# **A G E N D A**

## **Architectural Review Board**

**February 28, 2017**

# New Shed – Rendering

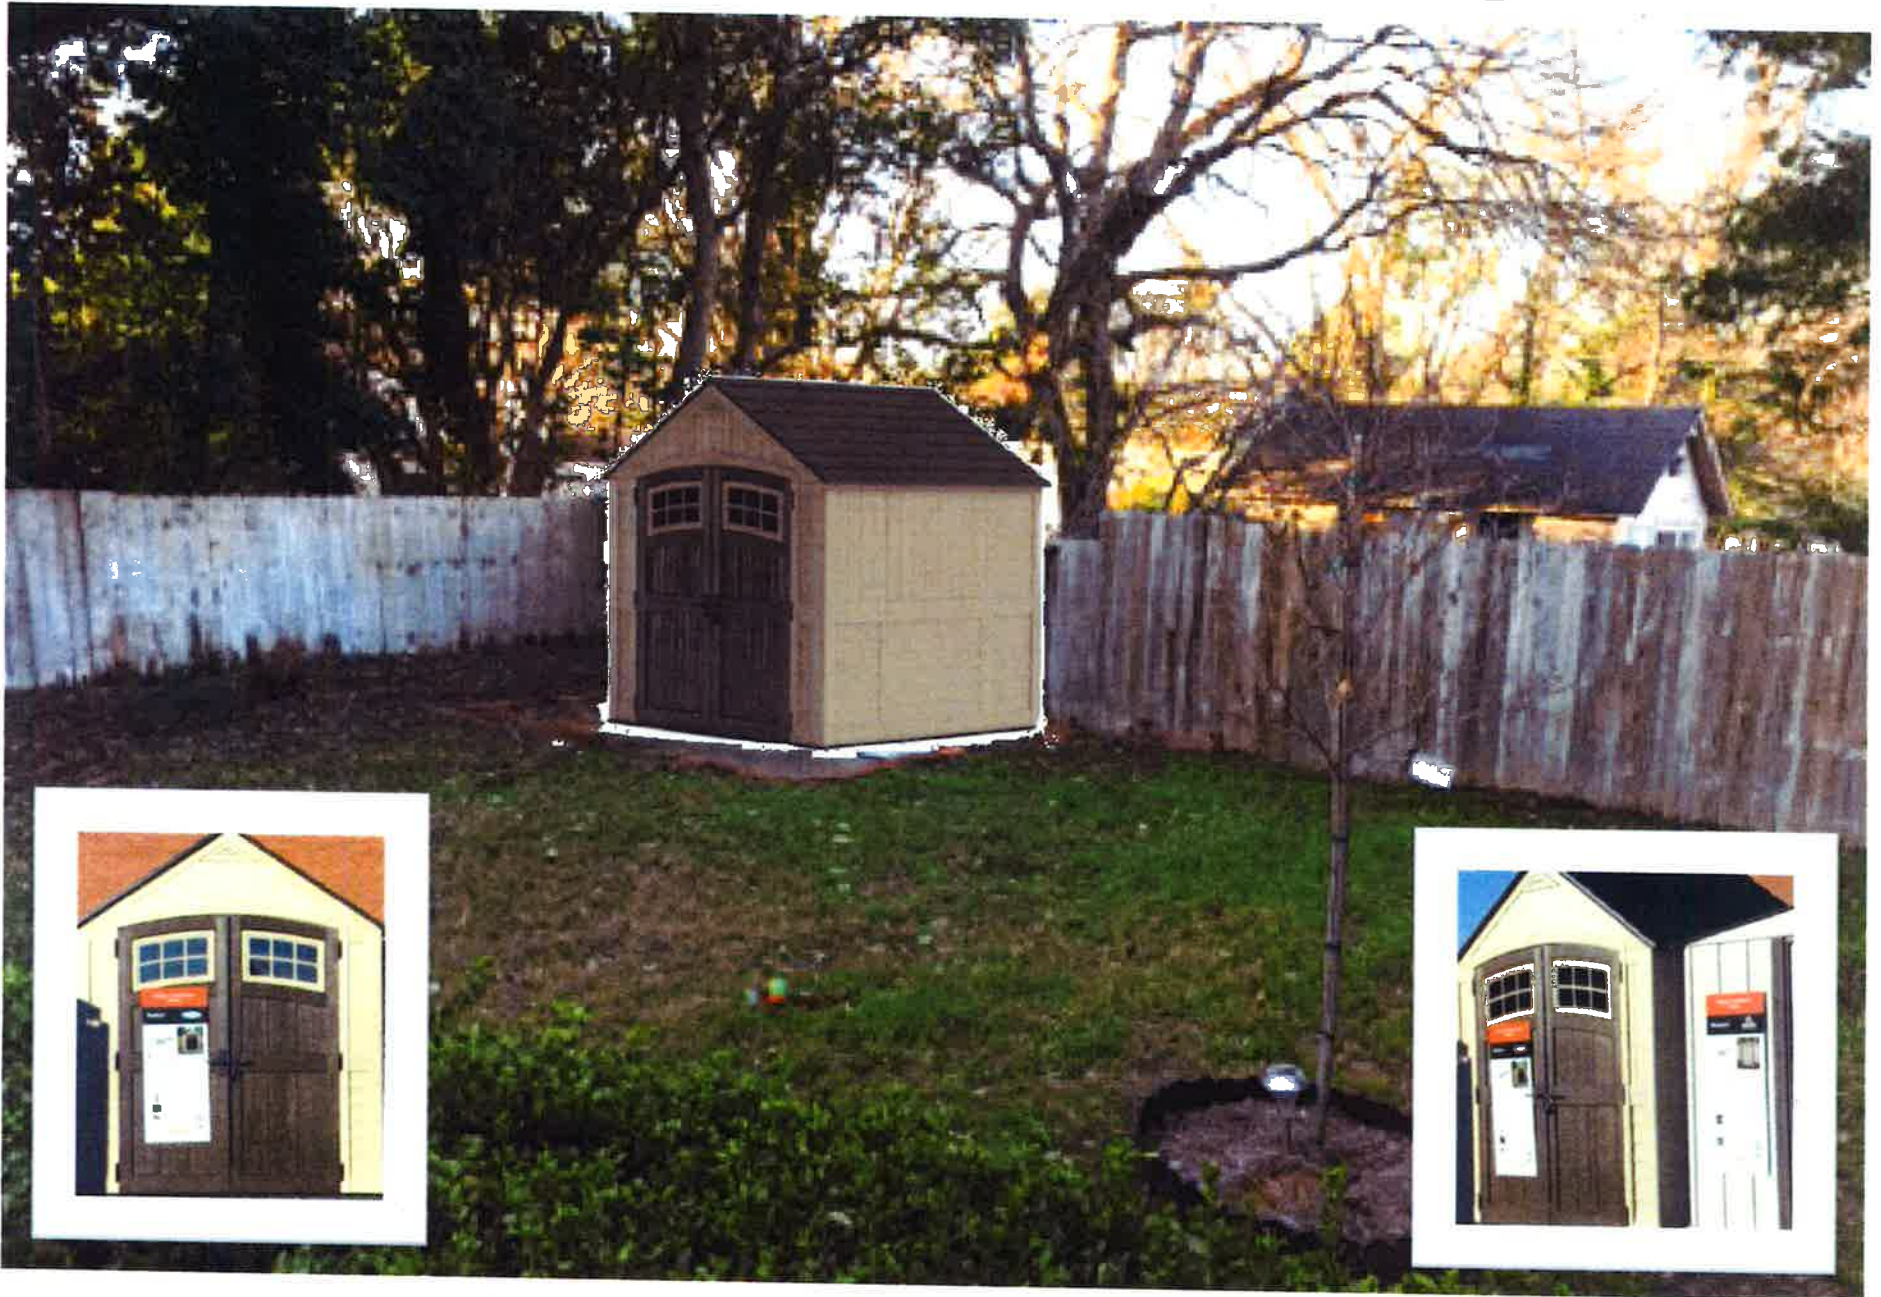
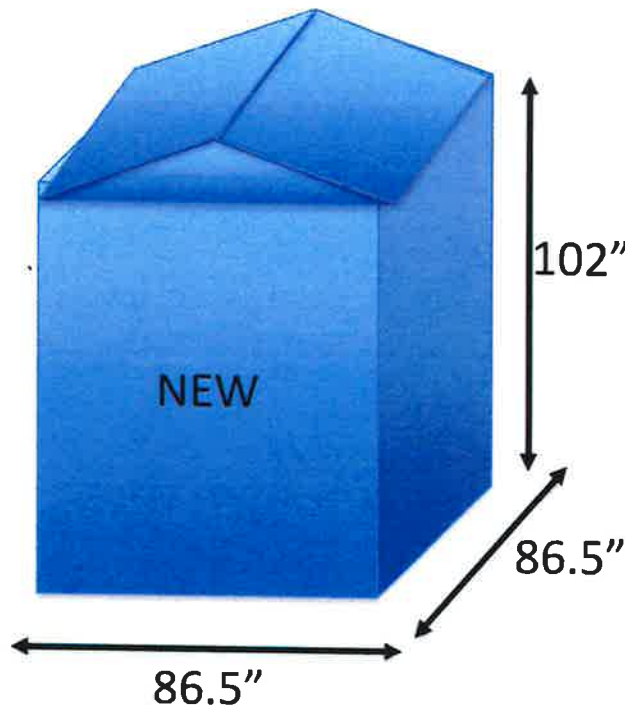
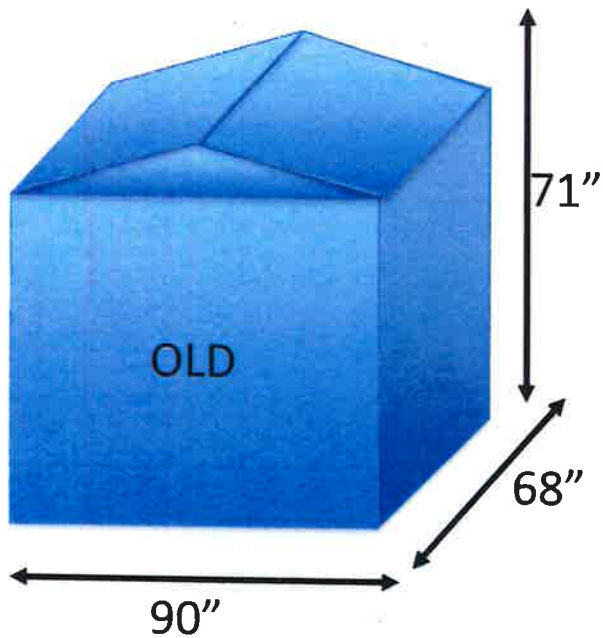
The second request is to remove and replace an existing metal storage shed. The new shed would be located on the same concrete pad, measure 7'x7', and the proposed replacement is a resin Suncast Shed.

- The proposed shed is more compatible in style than most of the prefabs we've seen to date. And it's small. But, it is resin. Is this an acceptable material? Does this render it a less permanent structure? Does that matter? Is something that is visually more compatible but constructed of non-historic a compromise bridge between the vertical plywood barns and a stick built shed?
- A half sized cousin of this structure was part of a petition on Cloverdale Road several years ago. It had a shed roof, was placed against a brick wall in the yard, and had a vegetative screen between it and the neighbors.

1207 Woodward Avenue

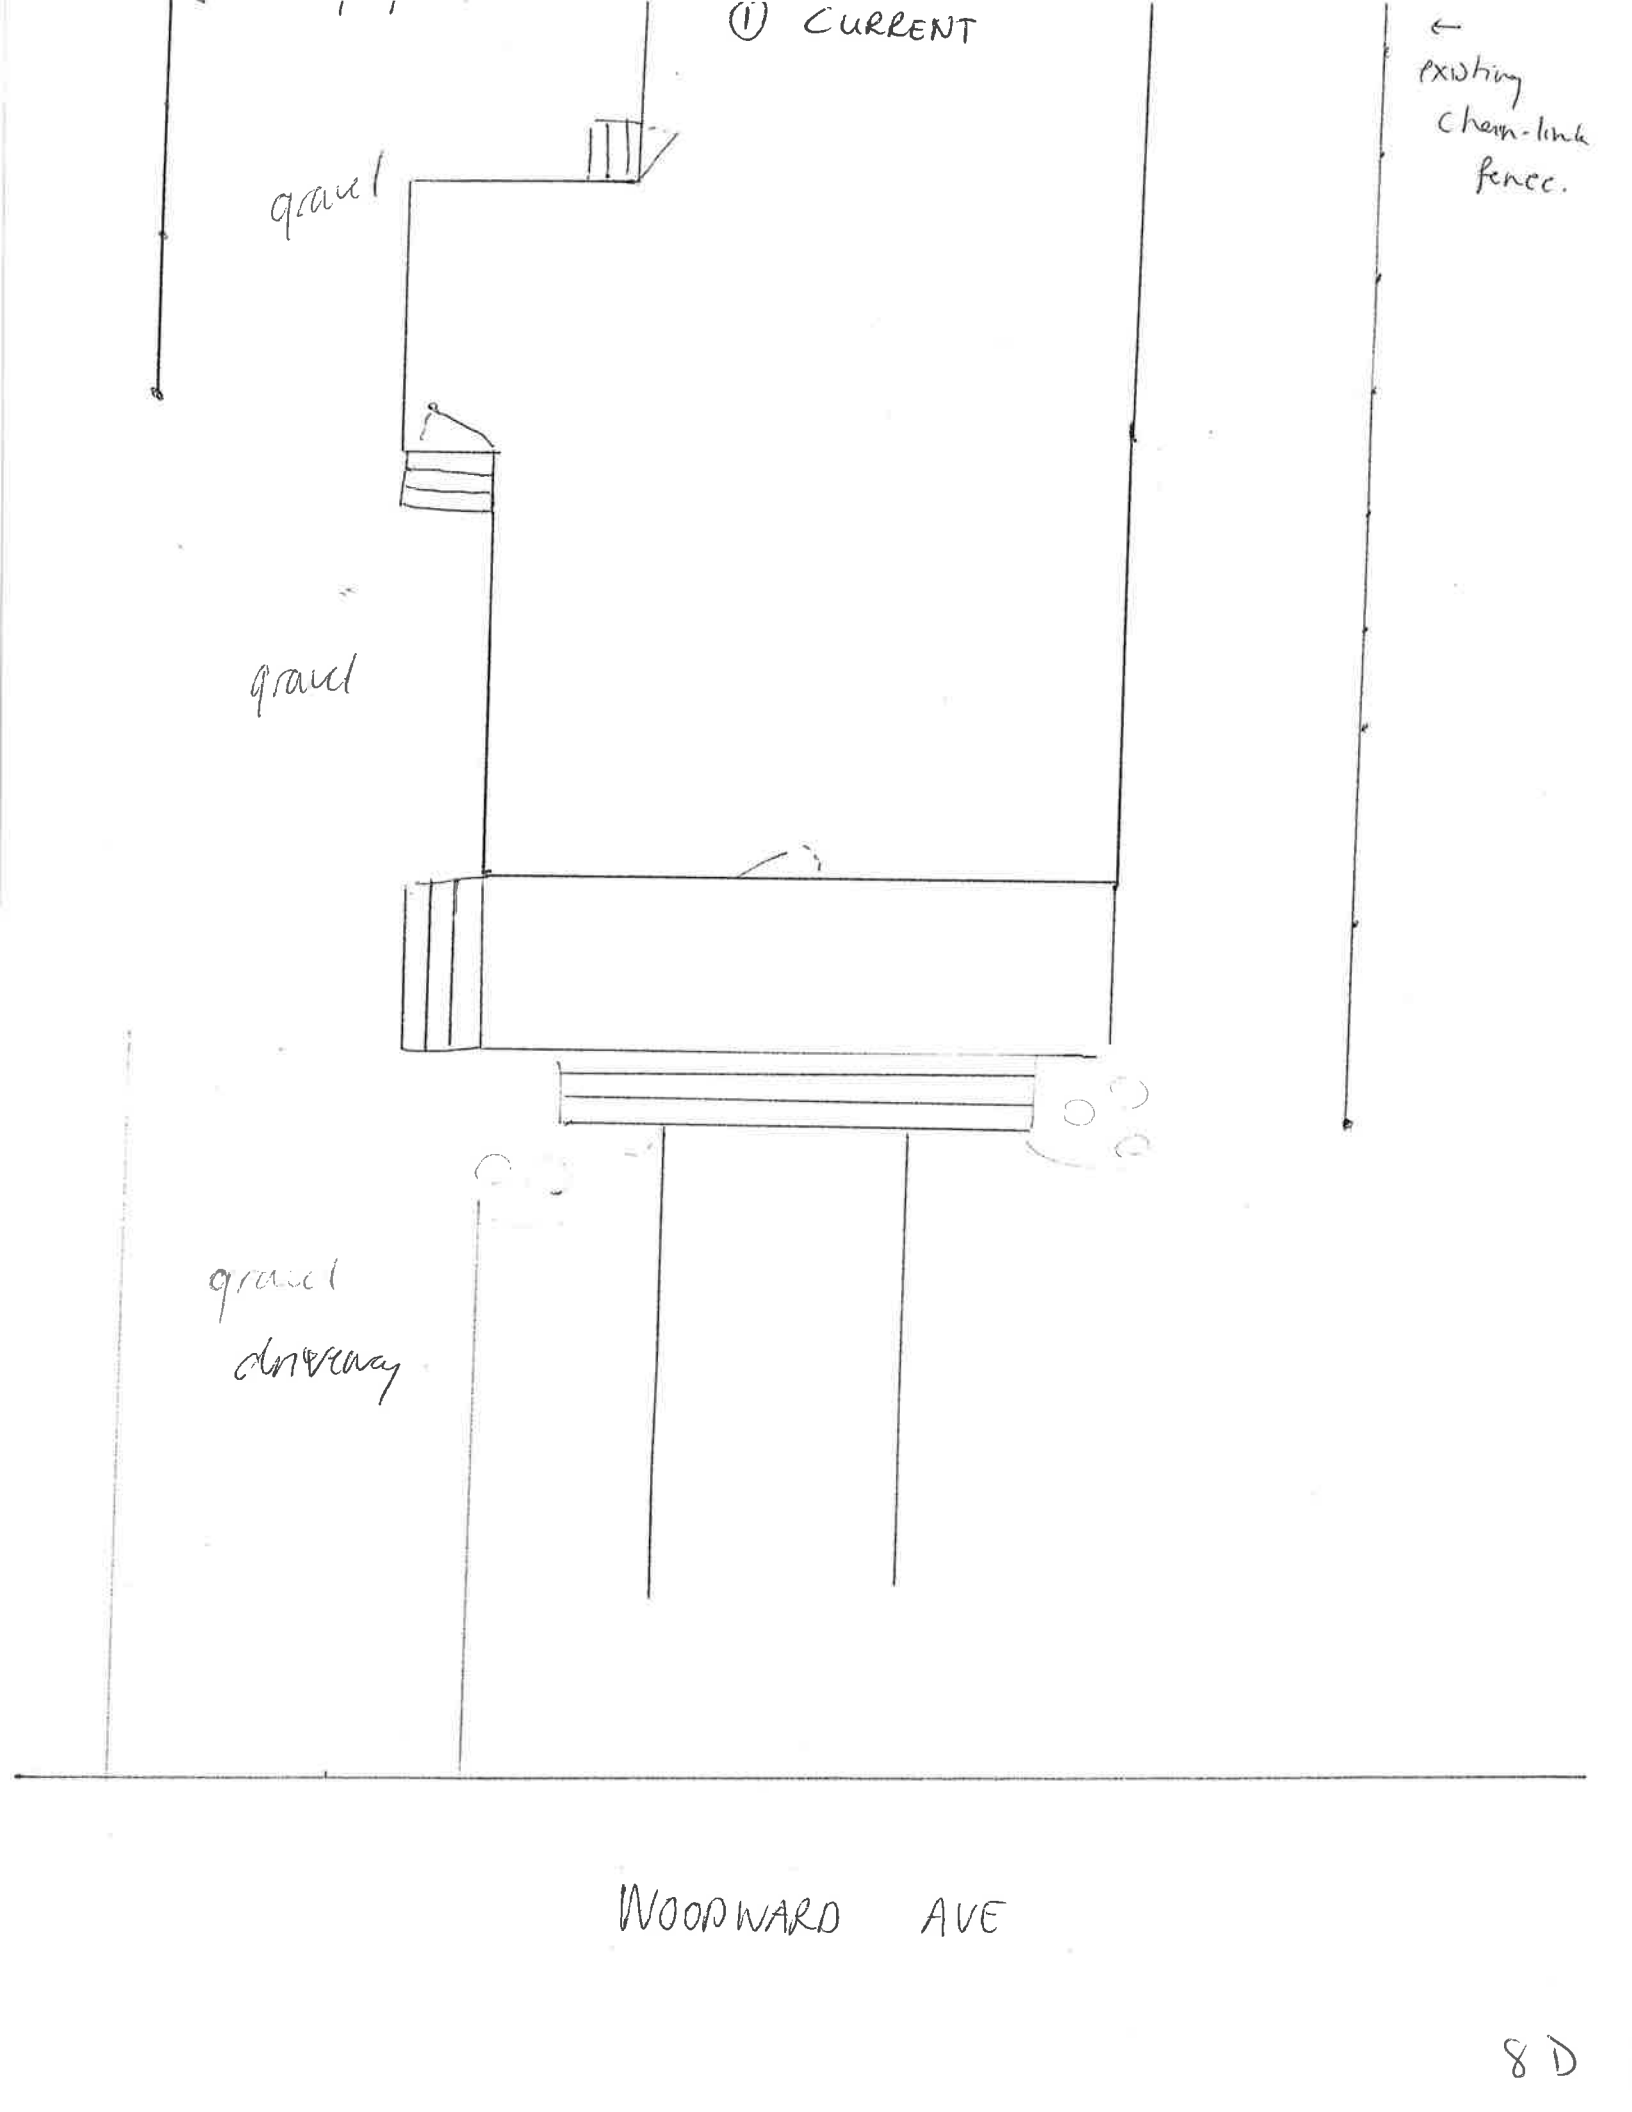
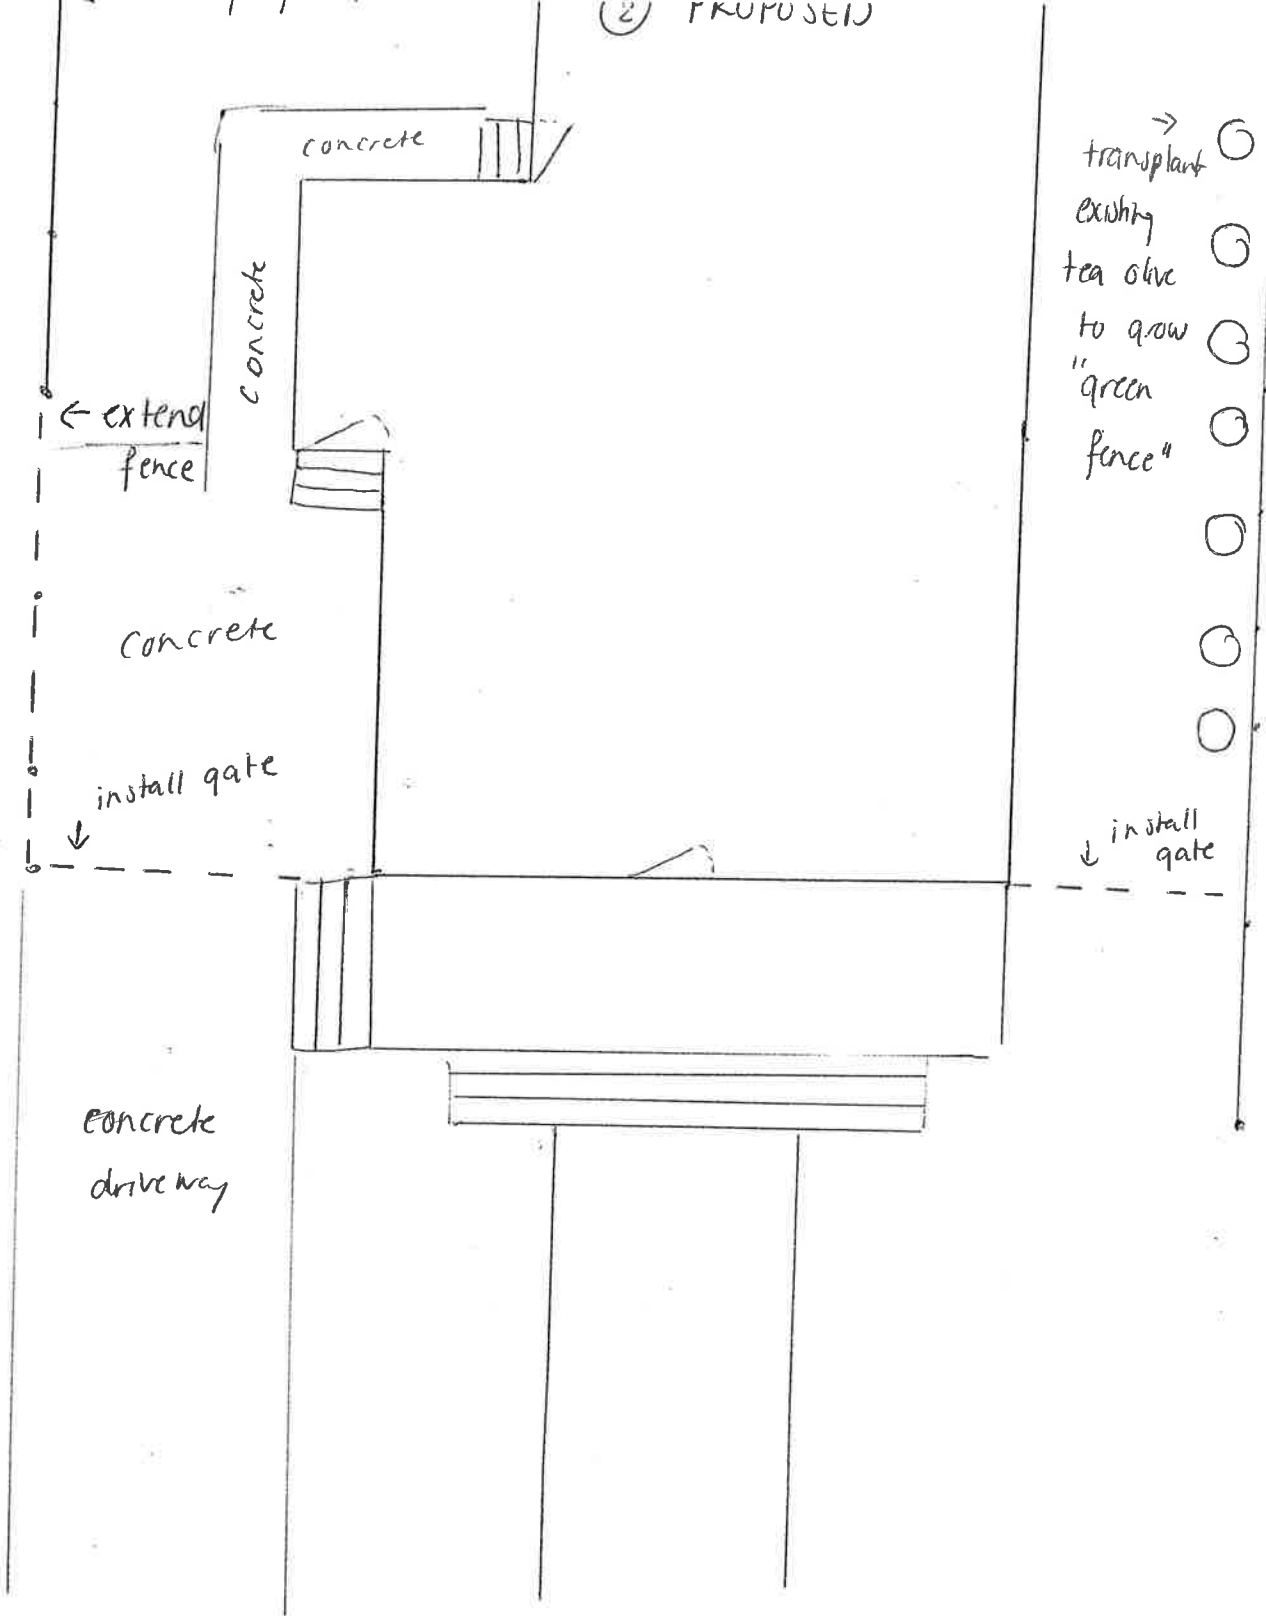
**REMARKS:** The petitioner is requesting permission to extend an existing fence between this property and the property to the west (1201), and install matching gates at the front corner of the house (not the porch) to each property line. The fence and gates will be black welded wire horse fence (no climb/dog proof). On the rear the petitioner would like to remove an existing chain link fence and replace it with the black horse fence where illustrated. The petitioner is also proposing replacing the existing gravel driveway with concrete in the same footprint.

- Wire and chain link fence was historically used to enclose rear yards. A black wire fence will disappear into the background, and be less visually intrusive than a wood privacy fence.
